Docket No. 50-249

Change No. 16
License No. DPR-25

NOTICE OF ISSUANCE OF CHANGES TO
TECHNICAL SPECIFICATIONS OF FACILITY OPERATING LICENSE

FIGURE 3.5.1 - MAXIMUM ALLOWABLE PLANAR LHGR

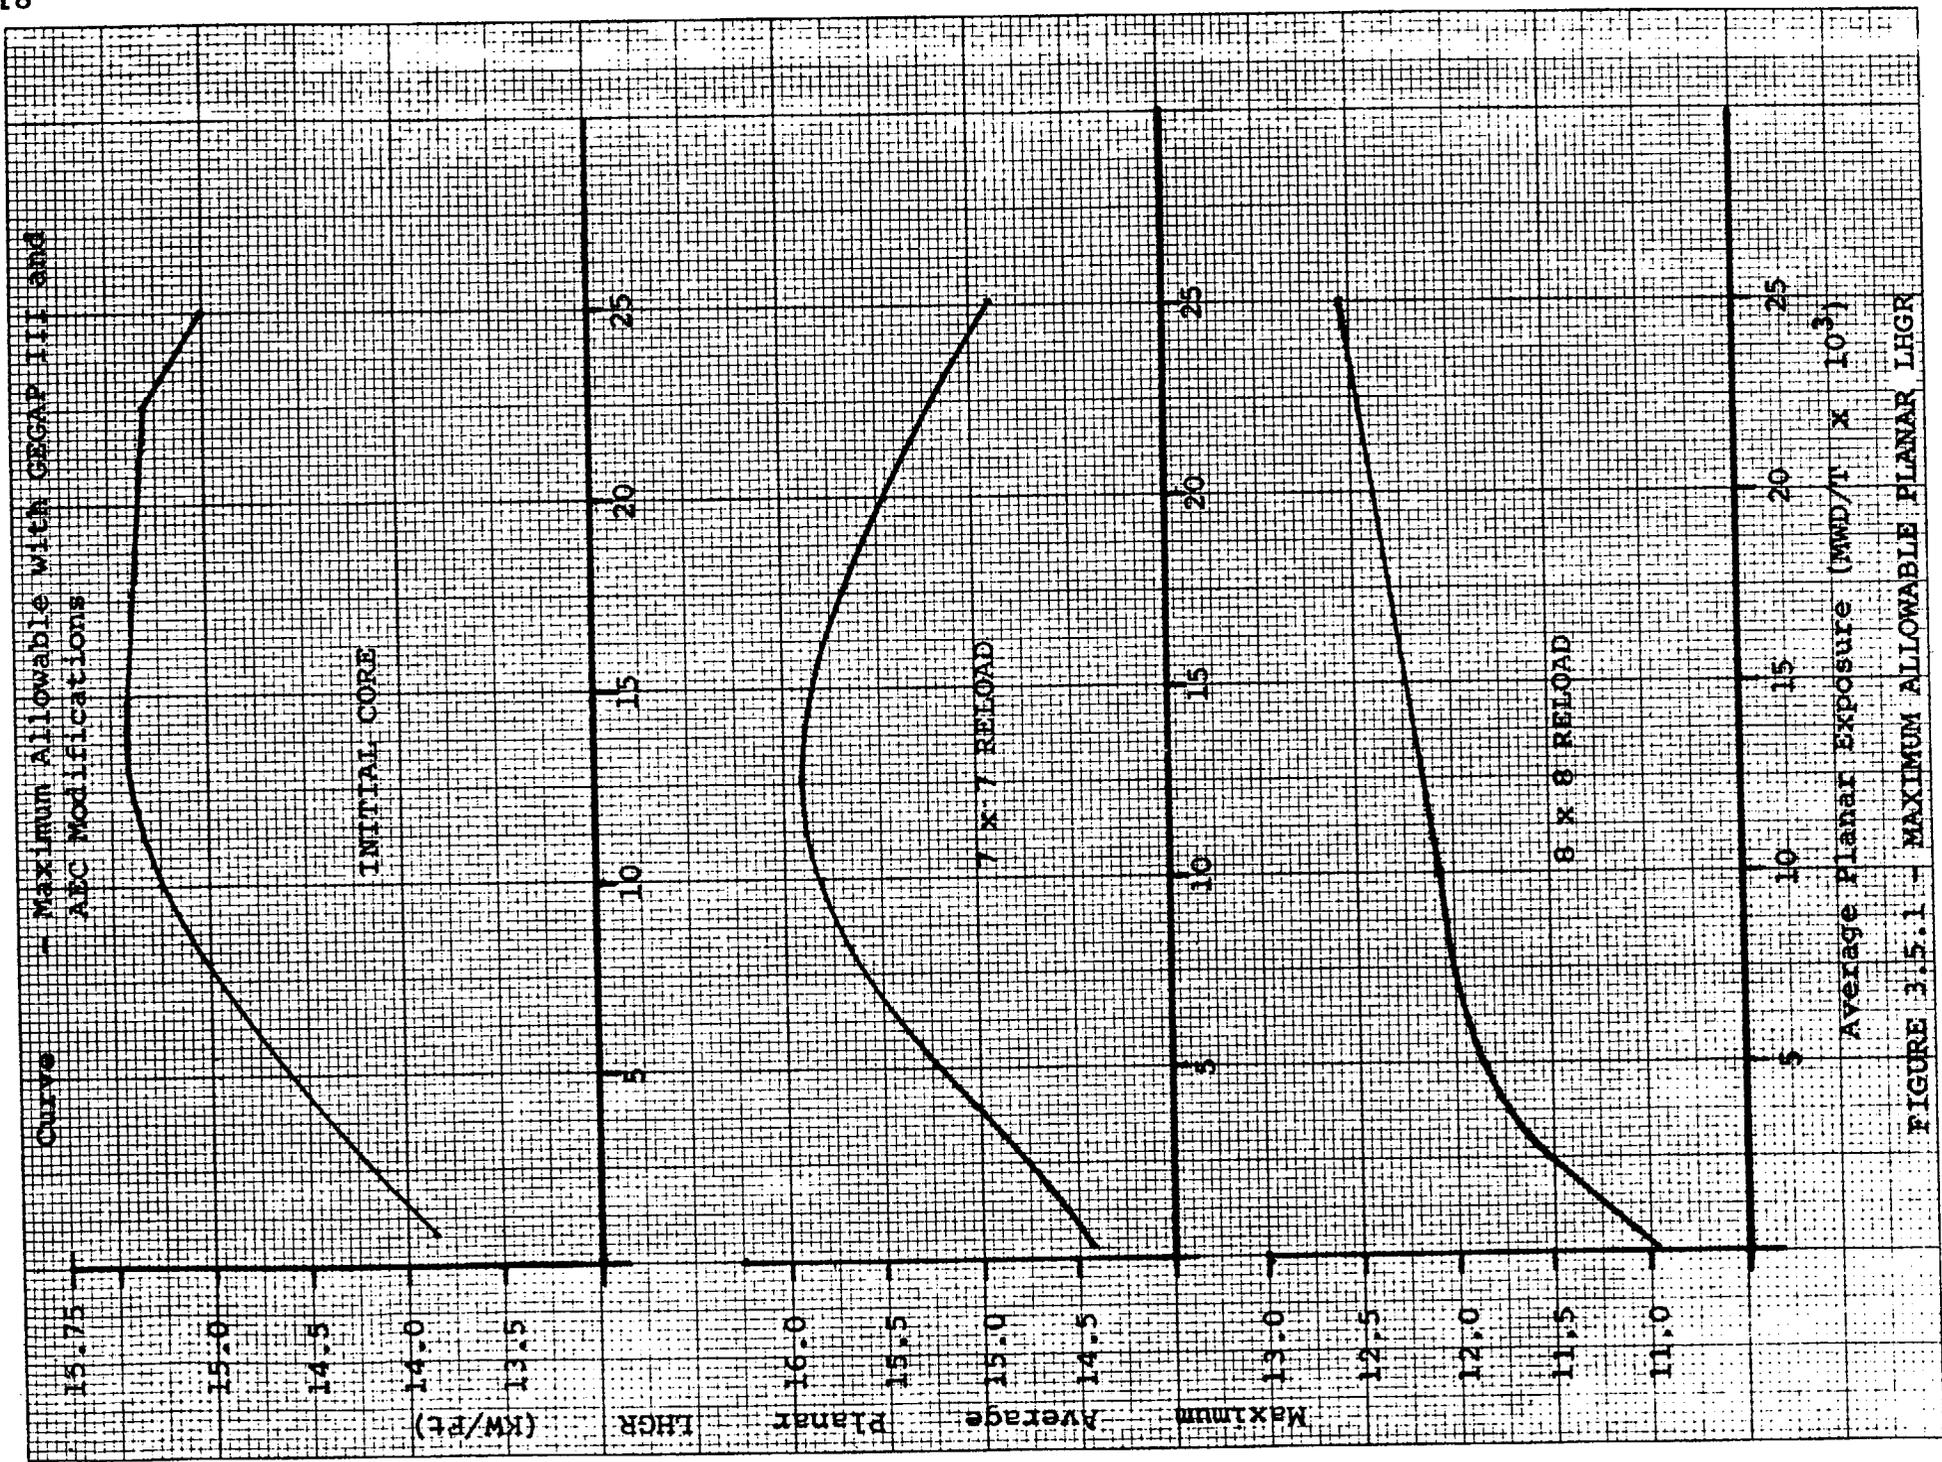
During steady state power operation, the average linear heat generation rate (LHGR) of all the rods in any fuel assembly, as a function of average planar exposure, at any axial location, shall not exceed the maximum average planar LHGR shown in Figure 3.5.1.

The maximum average planar LHGR's shown in Figure 3.5.1 are based on calculations employing the models described in the General Electric Report NEDM-10735 as modified by General Electric Report NEDO-20181 including modifications made by the Atomic Energy Commission transmitted to Commonwealth by letter dated December 5, 1973.
